**SERVICE LETTER NUMBER 170**  
**AIR TRACTOR EMPENNAGE CRACKS**

<b>By:</b> RCG	<b>Aircraft Makes/Model(s):</b> AT-802 AT-802A	<b>Float Model(s):</b> 10000A	<b>Note(s):</b> Mandatory Compliance Service Letter P/N 1009111 ECO 24720
<b>Approved:</b> JRS			
<b>Date:</b> 10/24/2016			
<b>Rev:</b> A

This service letter applies to: Air Tractor models AT802 and AT802A with Wipline 10000A Fireboss Amphibious Floats installed per STC SA01795CH

**FIGURE 1**

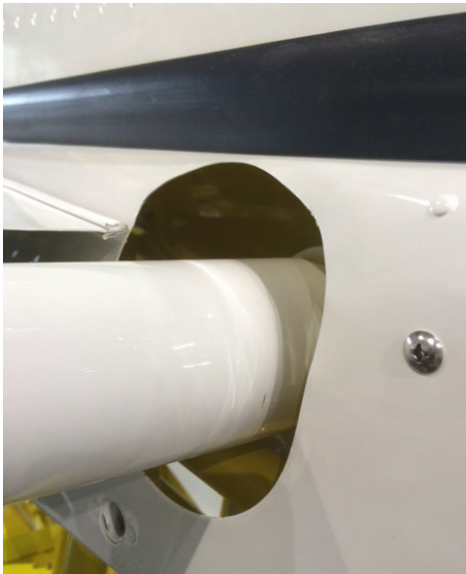
Inspect critical areas every 50 hours. Use an inspection mirror and flashlight to look for cracks on the pedestal mounts. Use the access location shown in Figures 1 through 4. At certain angles, deformations in the paint may be seen. These deformations could signify a fracture has been created under the paint and should be addressed immediately. Cracks that have broken through the paint should be addressed and repaired with the use of Air Tractor Service Letter or Service Kit, or any additional guidance given by either Air Tractor or Fireboss on a case by case basis.

Inspect critical areas every 50 hours. Use a 6 or 8 mm borescope to inspect the locations shown in Figures 1 through 4 and the pedestal mount for any deformation in paint or signs of cracking.

**FIGURE 5 (AT-802A)**

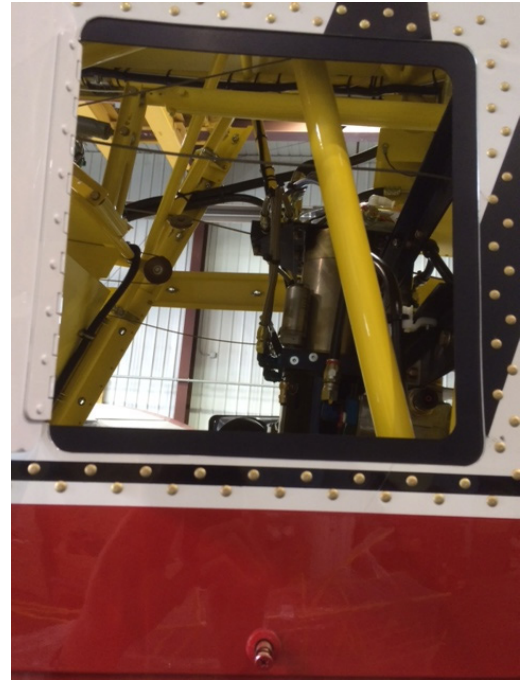
1. Identify the location on the tube behind the hydraulic access door to install the assembly. Make sure that the bung is mounted so that the gauge assembly can be installed and viewed easily when installed as shown in figure 5 and 6 for the AT-802A Fireboss and figure 7 and 8 below for AT-802 Fireboss

-301 TAIL PANEL ASSEMBLY - LH SIDE SHOWN, RH SIDE OPPOSITE

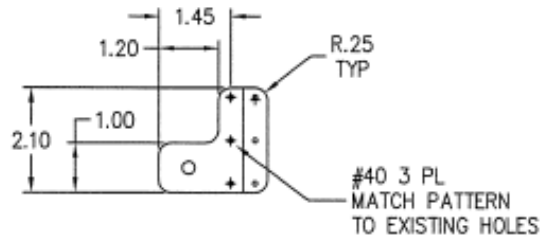
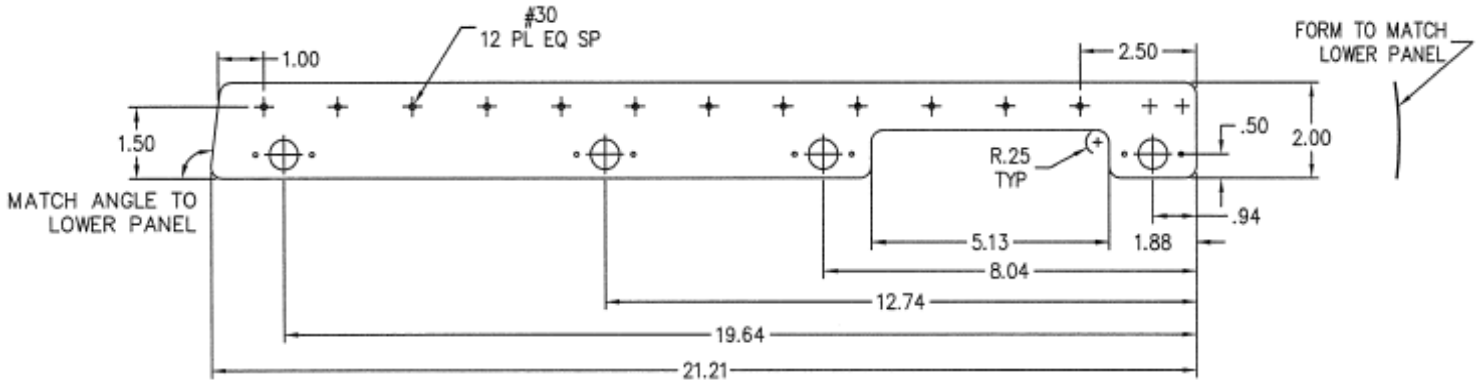
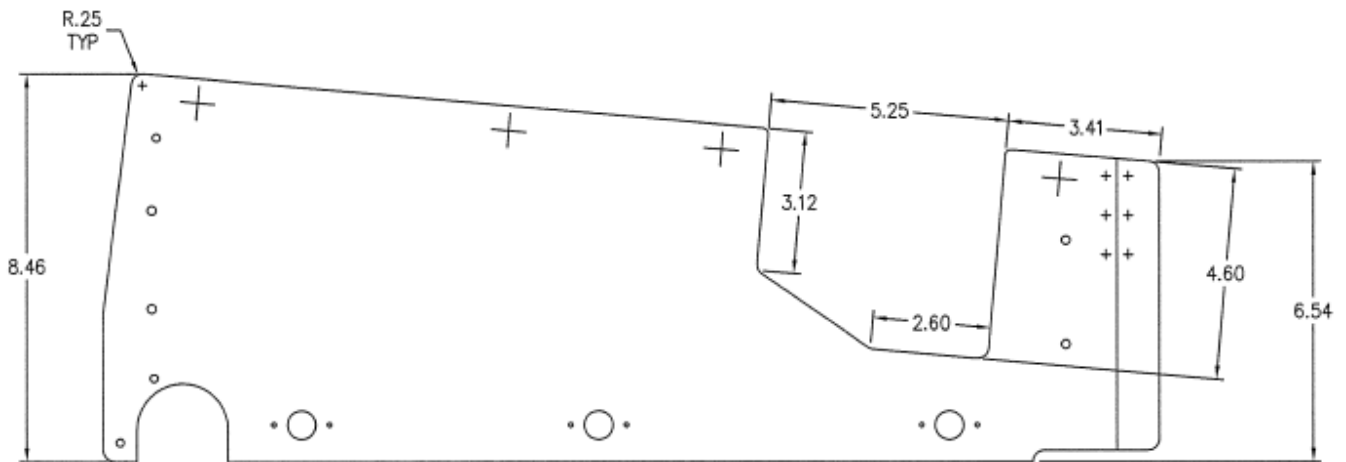
3. Make the following modifications to tail panel:
